# Design Review Board Agenda

**CITY OF MILL CREEK  
DESIGN REVIEW BOARD  
APPLICATION PL2018-0016**

**NAME OF PROJECT:** The Pointe Residential Identification Sign

**PROPOSAL:** Review of one residential identification sign.

# Attachment 1 - Existing Site Photos with Proposed Sign and Rockery

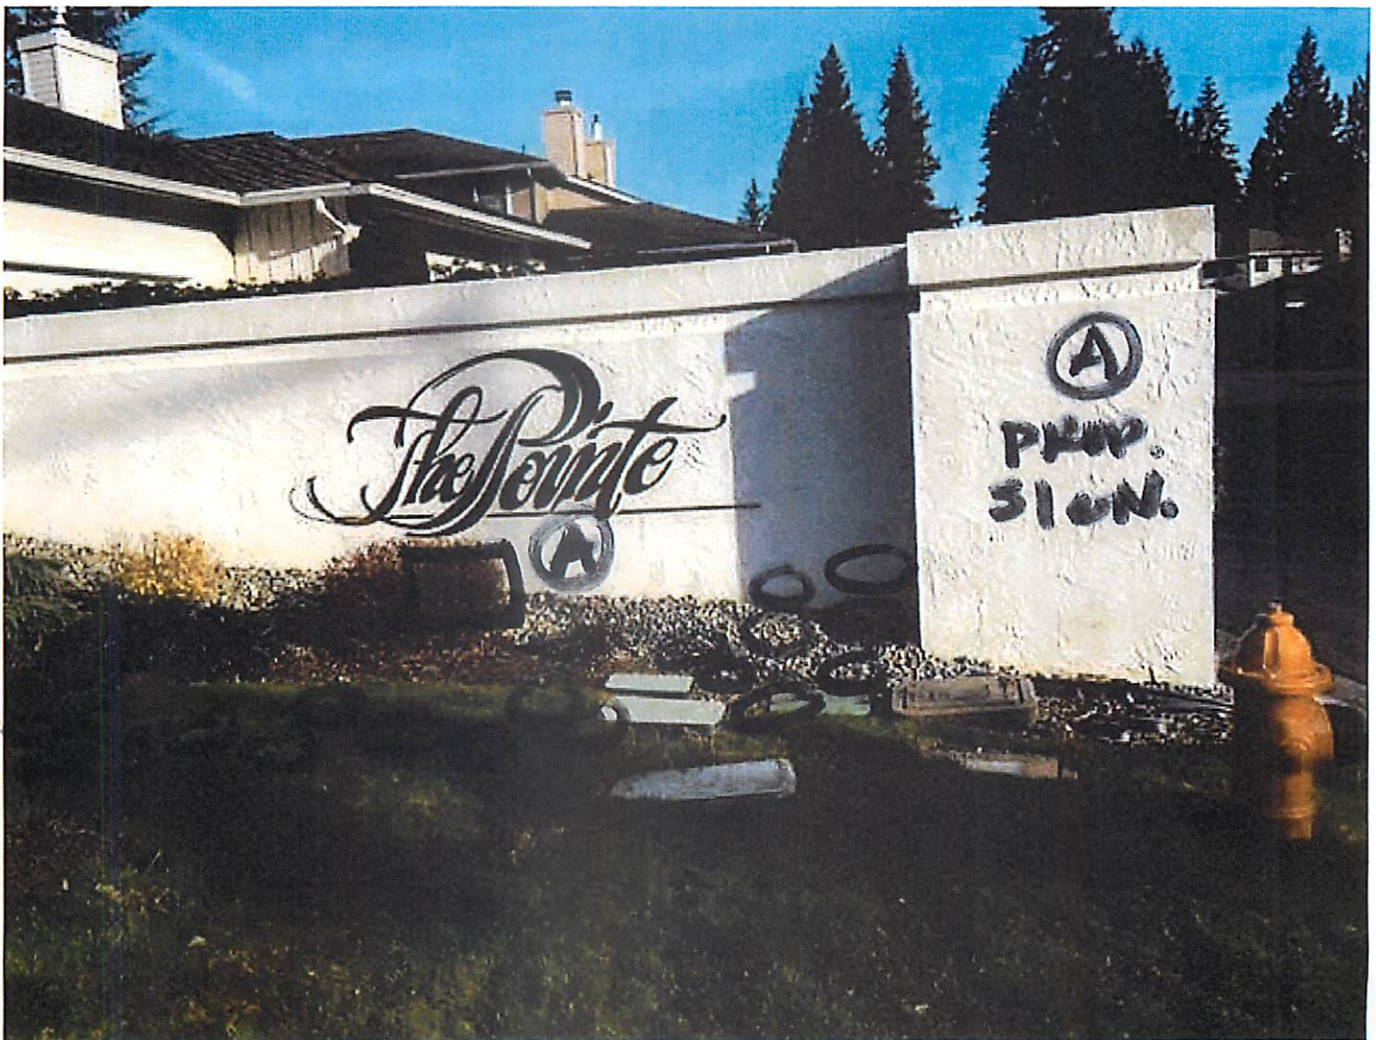
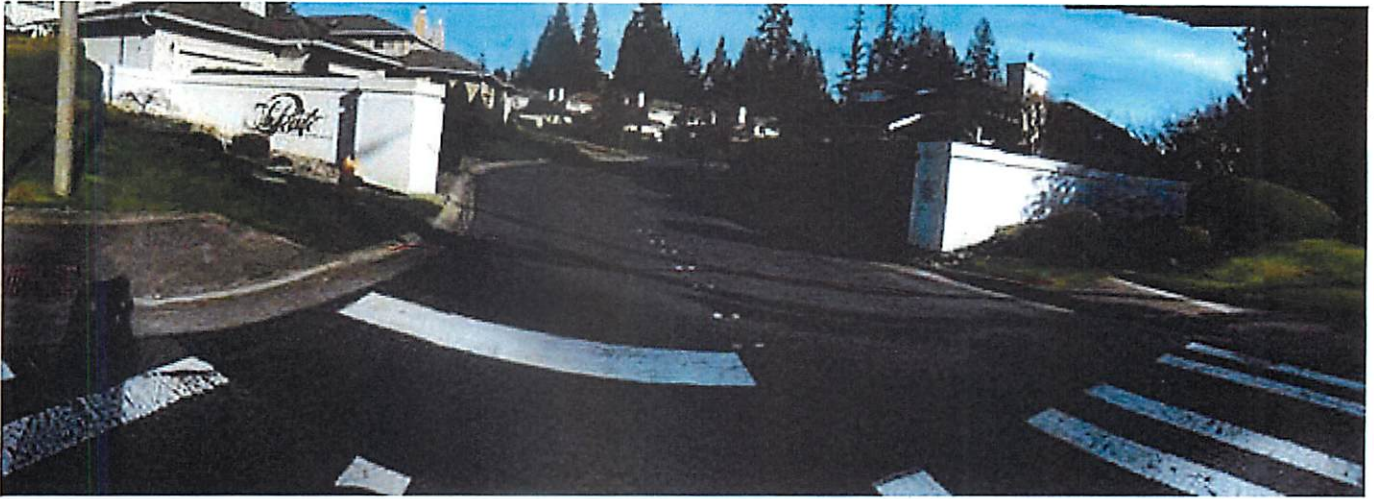
The applicant is proposing to remove the existing wall sign and install a flat stone facing Mill Creek Road in front of the wall where the existing wall sign is located. The location and design of the new sign is shown on Attachments 1, 2 and 3. The rock is proposed to be 55 inches wide and 48 inches in height and will be mounted in a concrete base. Total sign area is 18.3 square feet. The text will be engraved and the text will read “The Pointe” and the existing LED landscape lights will be retained and used to light the sign at night. The proposed sign size and design is consistent with the dimensional requirements contained in the Code.

The freestanding sign is proposed to be located in an existing landscape bed. The HOA is proposing to expand and level the landscape bed to surround the new sign and install a rock border to complement the new sign. Currently, there is minimal landscaping where the sign will be located, primarily lawn (see **Attachment 1 – Existing Site Photos with Proposed Sign and Rockery**). The existing plants and shrubs are proposed to be reused in the new landscape bed and new plants will be selected by the HOA to enhance the existing plants. The Code does encourage landscaping with flowering trees or seasonal annuals to accent a subdivision entrance. Thus, staff is recommending as a Condition of Approval that the HOA plant seasonal annuals in the proposed landscape bed surrounding the sign.

1. The sign design, materials, and colors shall be as portrayed on the materials submitted with the application, except as may be modified by the conditions imposed by the Design Review Board.
2. The sign shall not be installed until a sign permit is issued by the Building Official.
3. The landscape plan shall be as portrayed on the materials submitted with the application, except as may be modified by the conditions imposed by the Design Review Board.
4. The HOA shall include seasonal annuals in the landscape plan to enhance the subdivision entrance as well as the sign.

## Attachment 2 - Proposed Sign Design

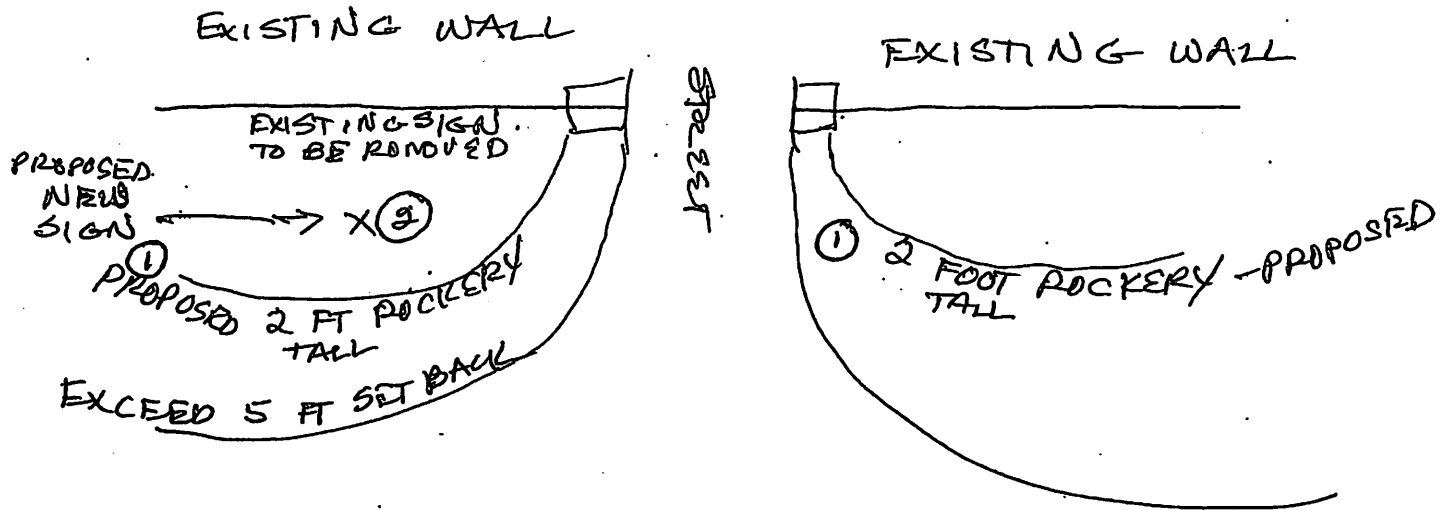
The stone sign is complementary to the new landscaping and will be compatible with the adjacent residences, in accordance with MCMC Section 17.34.040.G.3.

As proposed staff believes the new monument sign is consistent with the Mill Creek Municipal Code.
